REFERENCE:	TSB: 08-107-23 GROUP 08 - Electrical	Date:	April 22, 2023	REVISION:	-
VEHICLES AFFECTED:	2022 (WD) Dodge Durango This bulletin applies to vehicles built on or after May 18, 2022 (MDH 0518XX) and on or before August 15, 2022 (MDH 0815XX) equipped with a 140 mph Primary Speedometer (Sales Code JCE) or a 300 kph Primary Speedometer (Sales Code JDU).	MARKET APPLICABILITY:			
CUSTOMER SYMPTOM:	IPC is missing graphics and/or the speedometer, digital tire pressure and temperature units are incorrectly displayed for market (Metric/Imperial) (Fig. 1) . NOTE: Speed unit of measure can still be viewed in MPH from the center display (when analog speedometer is displaying KPH) and toggled to the correct units required for the market. Low tire pressure warning still functions properly.				
CAUSE:	Incorrect IPC displays.

Fig. 1
Incorrect And Correct IPC Displays

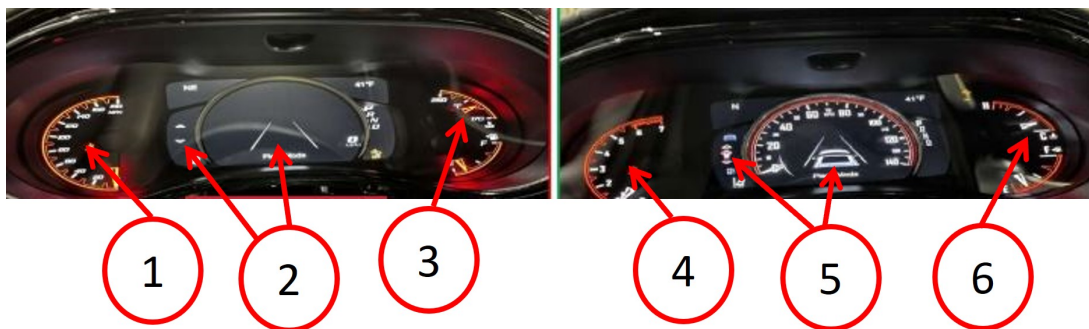
- 1 - Speedometer Shown - Incorrect
- 2 - Missing Graphics - Incorrect
- 3 - Degrees Fahrenheit Shown - Incorrect
- 4 - Tachometer Shown - Correct
- 5 - Graphics Displayed - Correct
- 6 - No Units Displayed - Correct

This bulletin involves replacing the IPC.
